THE ROVER COMPANY LIMITED

LAND-ROVER SERVICE NEWS LETTER

No. 7

February 1961

Fig. 2—Location stop fitted to axle
 A—Location stop

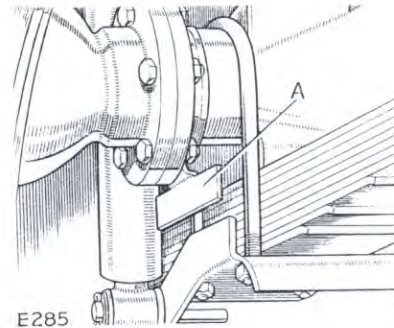
Item 42 SUBJECT: **LOCATION STOP FOR JACKING POINT**
 MODELS: Land-Rover Series II.
 MODIFICATION: Location stop added at joint flange of swivel pin bearing housing and axle casing to prevent jack platform from turning when lifting right-hand front axle.
 PART NUMBER: Location stop for jacking point 1 519206
 REMARKS: The location stop can be added to any earlier Land-Rover Series II model. It is retained by the two lower bolts fixing the swivel pin bearing housing to the axle case. See Fig. 2 below.

Fig. 3—Clutch linkage setting

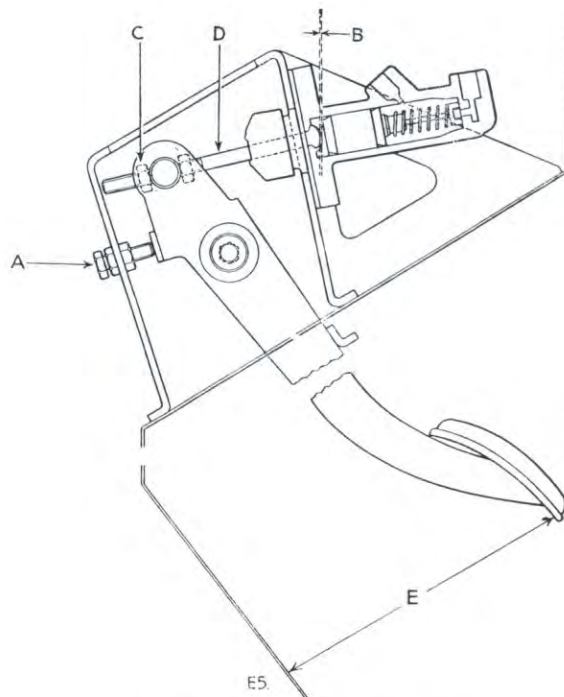
1. Check the free play between the master cylinder piston and the push rod. See Fig. 3. This free play should be $\frac{1}{16}$ in. (1.5 mm) at the push rod and is felt as approximately $\frac{5}{16}$ in. (8 mm) at the pedal pad. If the movement is less than the given figure:
2. Slacken off locknut and rotate the push rod with the fingers until the correct movement has been attained.
